NORTHEAST UTILITIES

Millstone Nuclear Power Station, Unit No. 2
Followup Actions to Amendment No. 90
to Operating License No. DPR-65

Additional Information Supporting
the Cycle 6 Reload Safety Analyses

Figure 1

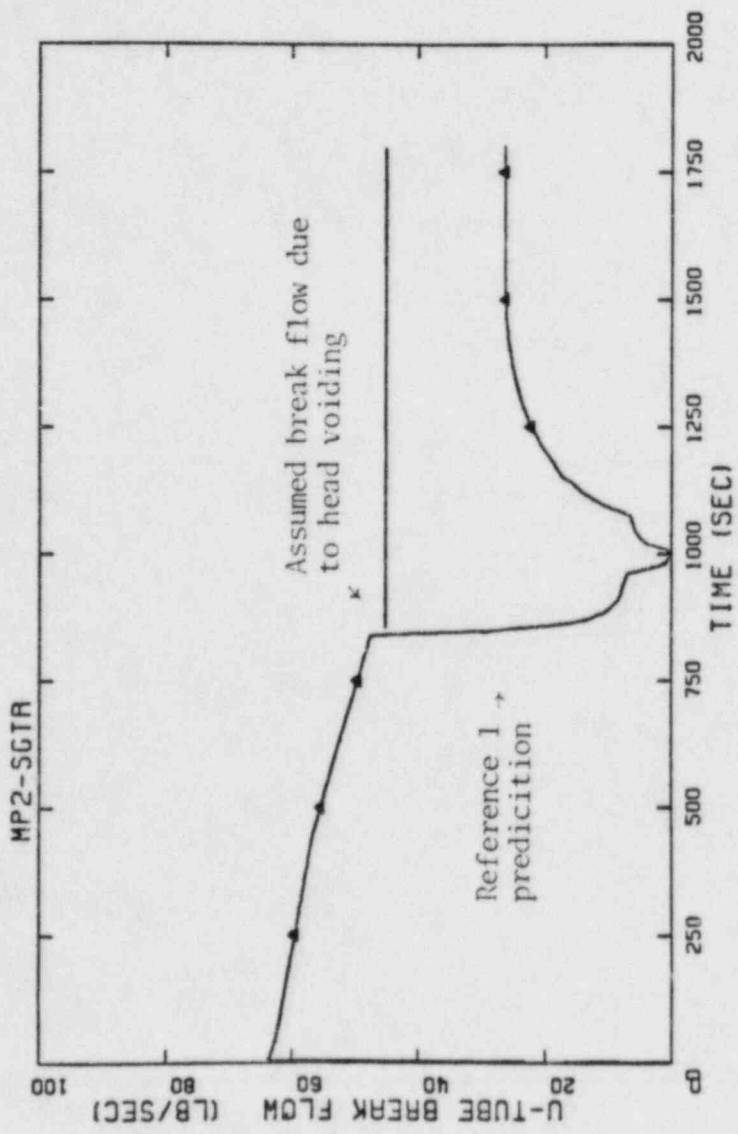
NNECO committed to provide the Staff the results of an evaluation of reactor vessel upper head voiding on the steam generator tube rupture accident assuming a 12% safety valve blowdown. NNECO had previously provided the results of the tube rupture analysis considering upper head voiding in Reference (3); however this evaluation assumed the steam generator safety valves reseal at their opening pressures. The impact of additional safety valve blowdown was addressed in Reference (4). This calculation provides the results considering the combined effects of potential upper head voiding and the worst case safety valve blowdown (12%).

Head voiding would cause a less rapid primary system depressurization and result in an increase in primary-to-secondary system break flow following reactor trip. The slower depressurization is caused by flashing of the hot water contained in the relatively stagnant head region. The calculation was performed with RETRAN02 MOD002. Although this calculation does not specifically represent the upper head in RETRAN, it conservatively bounds the possible increase in flow from the primary system into the steam generator that might be caused by upper head voiding. The maximum post-trip pressure drop between the primary and secondary systems corresponds to the saturation pressure of the upper head region (1600 psia) minus the steam generator safety valve closing pressure (870 psia assuming 12% blowdown). The increased break flow based on these conditions was modeled in RETRAN as a fill junction with a constant flow rate for the time following reactor trip. Since the increased break flow is modeled as a fill junction, the primary system response in this evaluation is essentially the same as that in Reference (4). Prior to reactor trip, the break flow is calculated identically to the Reference (4) calculation. A comparison between the break flow calculated in Reference (4) and this evaluation is shown in Figure 1.

This analysis predicts that the increase in steam flow to the environment caused by head voiding is bounded by 1.2 percent compared to the worst-case analysis presented in Reference (4).

The radiological dose for the worst case presented in Reference (4) is less than 1 Rem. The increase in offsite dose caused by an increase in steam release to the atmosphere of 1.2 percent is small and well within the 10CFR100 limits. It is therefore concluded that the effects of head voiding on the analyzed consequences of the Millstone Unit No. 2 steam generator tube rupture are negligible.
